Responses to RAIs for Topical Report EPRI-AR-1(NP)

Subject: Response to Request for Additional Information (RAI) on Topical Report EPRI-AR-1(NP), "Uranium Oxycarbide (UCO) Tristructural Isotropic (TRISO) Coated Particle Fuel Performance"

Response to EPRI-AR-1(NP) Request for Additional Information (RAI) #5 Related to Quality Assurance

Figure 1.

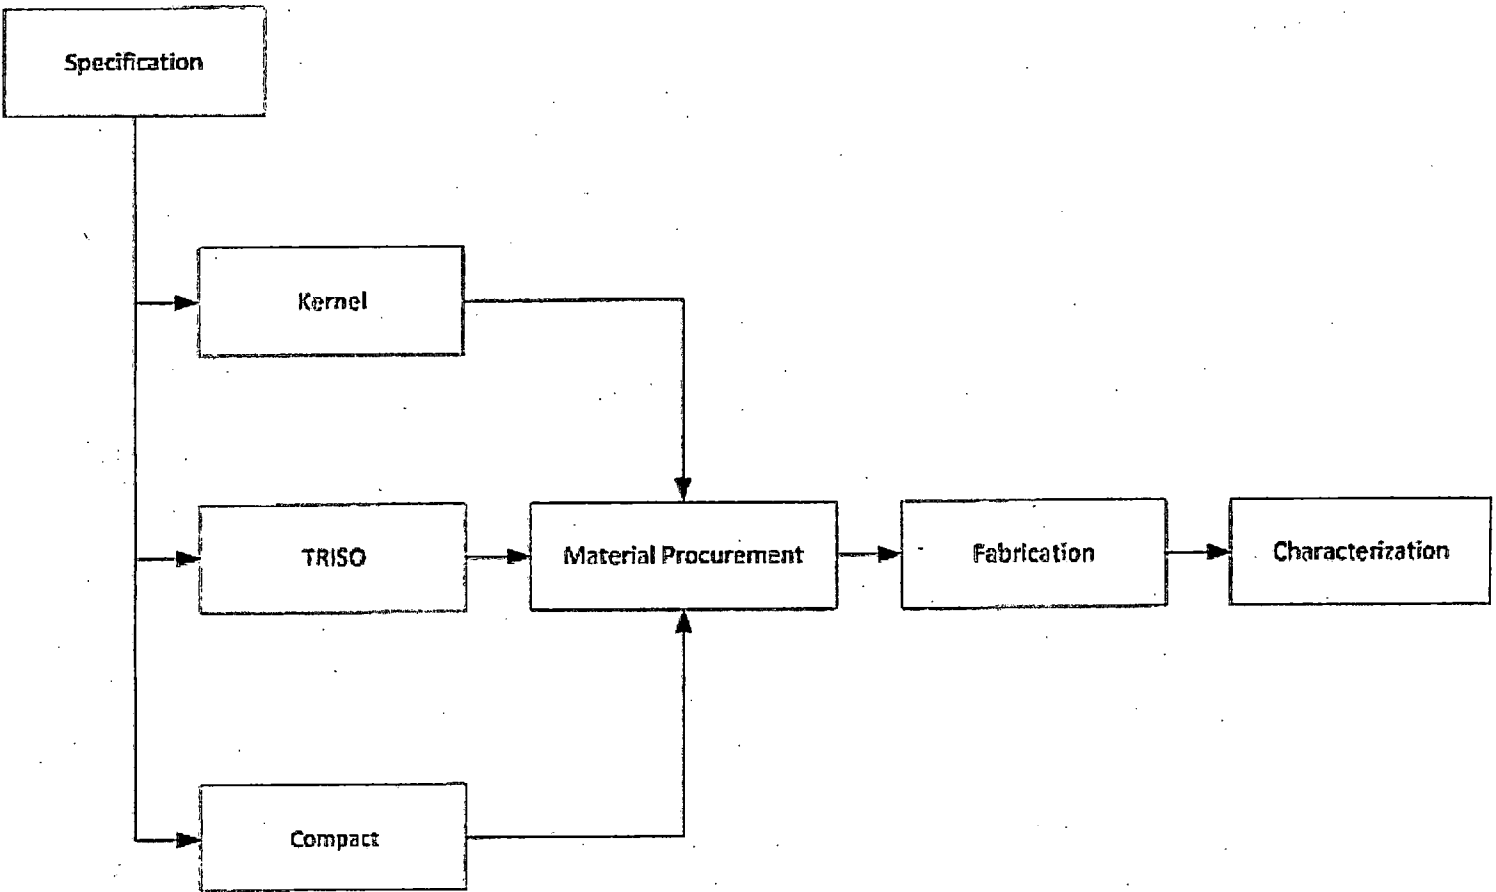
The staff assessment of "Next Generation Nuclear Plant Quality Assurance Program Description," dated September 12, 2012 (ADAMS Accession No. ML12241A157), found that the QAPD was acceptable for use during the technology development and high-level design phase of the NGNP project. As such, the staff is seeking clarification on the scope of the activities performed by Idaho National Laboratory to obtain and submit the data used by EPRI in their topical report titled "Uranium Oxycarbide (UCO) Tristructural Isotropic (TRISO) Coated Particle Fuel Performance: Topical Report EPRI-AR-1(NP)".

The Electric Power Research Institute topical report covers foundational fuel performance testing from the Advanced Gas Reactor (AGR)-1 and AGR-2 tests including the irradiation, safety testing and post-irradiation examination results. These research and development activities are associated with "technology development" activities, and the quality assurance standards reflected in the NGNP QAPD and assessed by the NRC staff were implemented during the performance of those activities. A summary depiction of the key technology development activities performed in conjunction with the overall data collection sequence of fuel fabrication, irradiation, and post irradiation examination (PIE)/safety testing is provided in the following flowcharts (Figures 1-3).
